Applicant : Yusuke Igarashi et al.
Serial No. : 10/588,467
Filed : October 3, 2007
Page : 6 of 11

Attorney's Docket No.: 14225-
0111US1 / F1040900US00

Amendments to the Drawings:

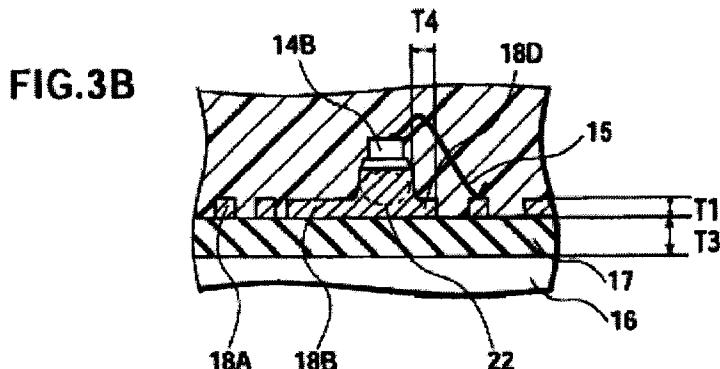
An example of those features is shown in FIG. 3B (reproduced below) of the present application. In that example, a hybrid integrated circuit device includes an insulating layer 17 formed on a substrate 16, and a first conductive pattern 18A and second conductive pattern 18B formed on the insulating layer 17. The second conductive pattern 18B includes a protruding portion 22, in which the portion 22 extends upward from a front surface of the second conductive pattern. The second conductive pattern 18B also includes an edge portion 18D surrounding the protruding portion 22, in which the edge portion 18D has a width T4 that is larger than the thickness of the first conductive pattern 18A and a thickness T1 that is substantially equal to the thickness of the first conductive pattern 18A (see ¶¶ [0082]-[0084]). By forming the protruding portion 22 on the second conductive pattern 18B, the overall thickness of the second conductive pattern in that area is increased. Accordingly, the increased thickness allows, in some implementations, the second conductive pattern to handle greater levels of current flow.
